INCH-POUND
MIL-M-21393A
AMENDMENT 7
8 August 2002
SUPERSEDING
AMENDMENT 6
15 November 1968

MILITARY SPECIFICATION

MICROPHONE, DYNAMIC, M-92C/U

This amendment forms part of MIL-M-21393A, dated 1 July 1960, and is approved for use by all Departments and Agencies of the Department of Defense.

FIGURE 1A. Hand-held microphones M-92C/U.

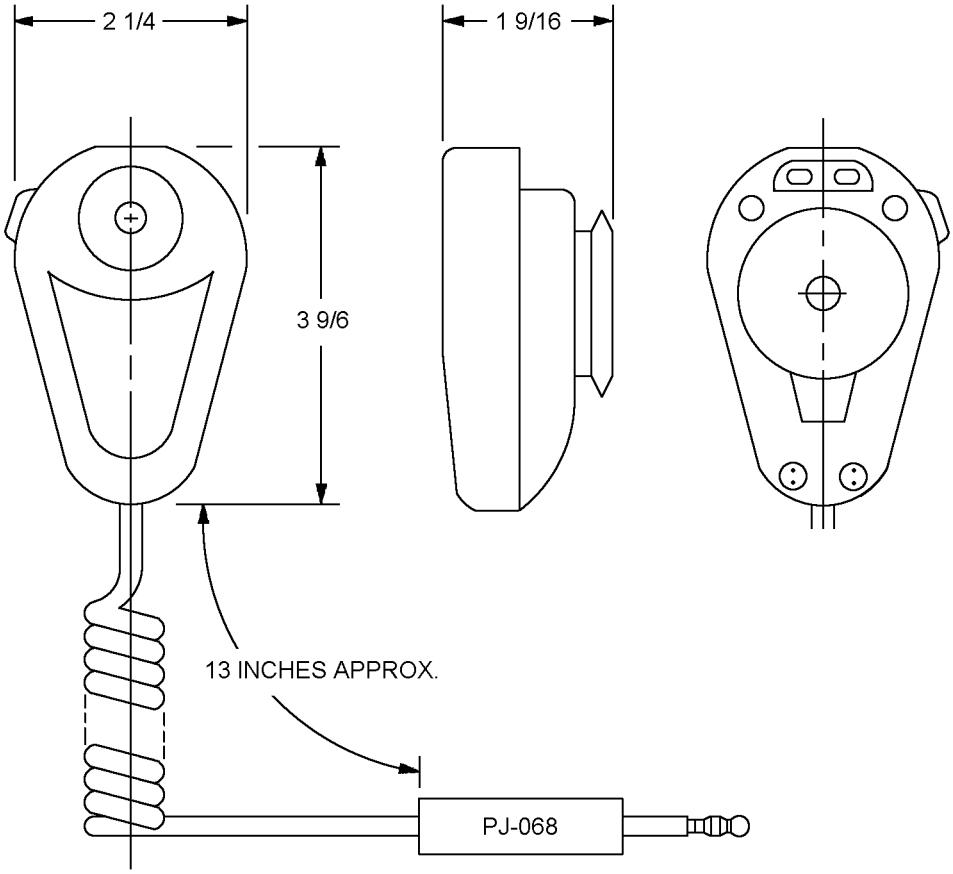
3.3.5, first sentence: Add: "or figure 1A".

3.4.1.2: Add: "or figure 1A."

"6.4 Ordering data – The procurement document should specify the title, number and date of this specification and configuration in accordance with either figure 1 or figure 1A of this specification."

FIGURE 12. Frequency response.

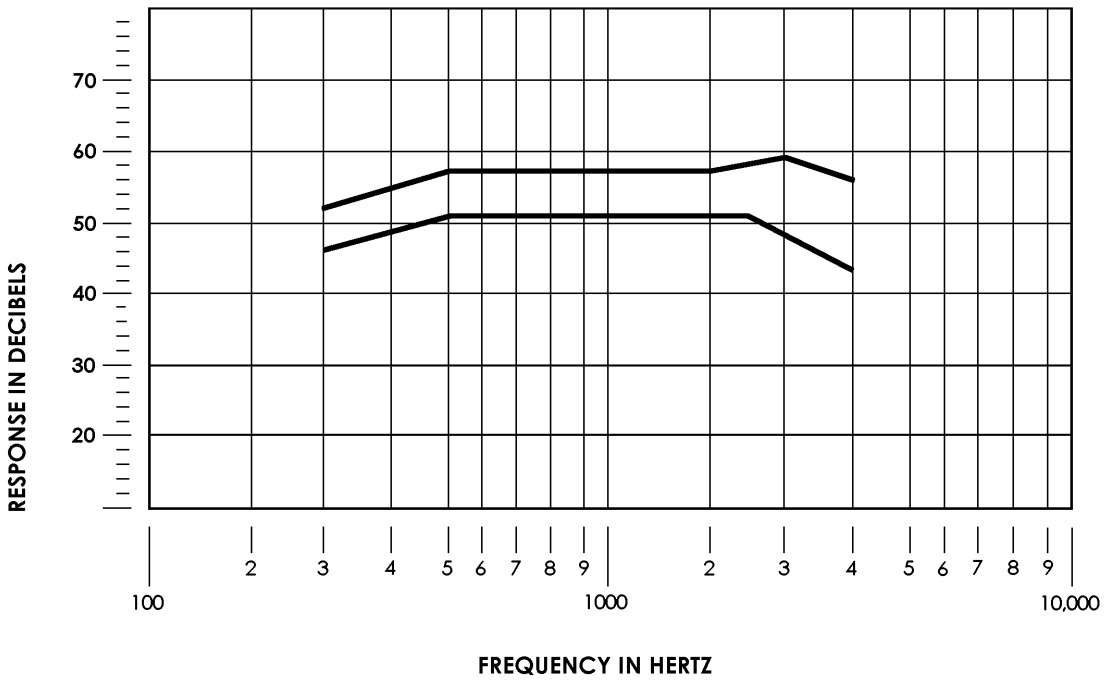
3.5.2: Delete "Table I" and substitute: "figure 12."

Table I: Delete and substitute: figure 12.

4.5.3.2: Delete "3.5.2 table I" and substitute: "figure 12".

FIGURE 13. Radiated radio frequency susceptibility test circuit.

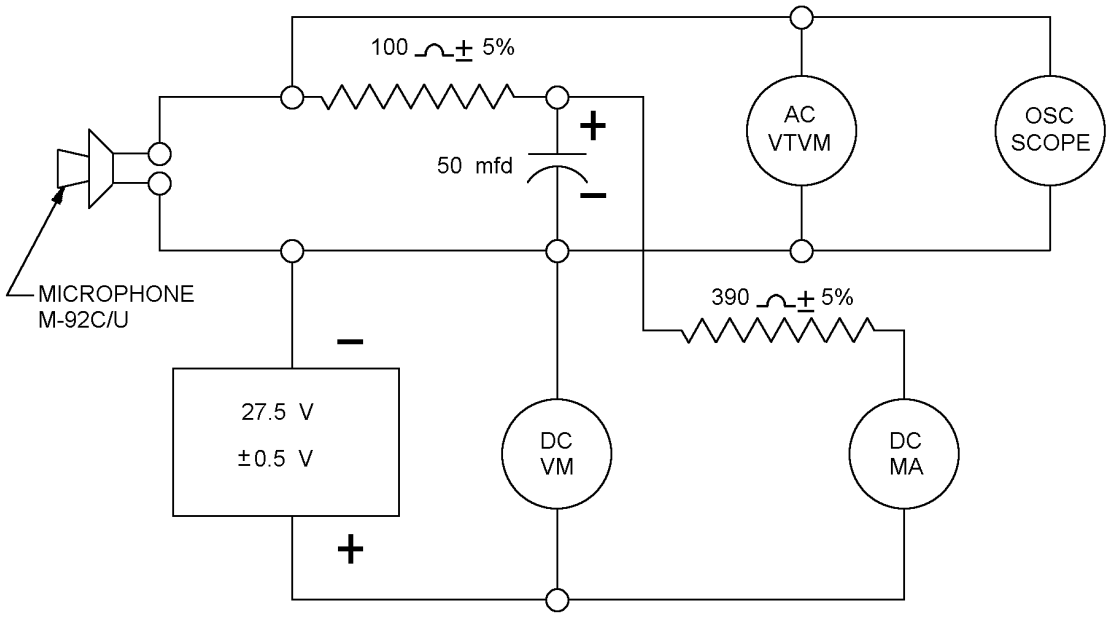
3.5.11.1 Radiated R. F. Susceptibility – The microphone, when connected as shown on figure 13, shall not evidence oscillation or other degradation of performance including extraneous signals or noise (i.e., output which does not correspond to a desired input) when subjected to any frequency and steady field intensity shown in table V. The microphone shall not evidence oscillation or other degradation when subjected to the required steady field intensity for a period of three minutes at nine frequencies including end and mid frequency of each frequency band of table V.
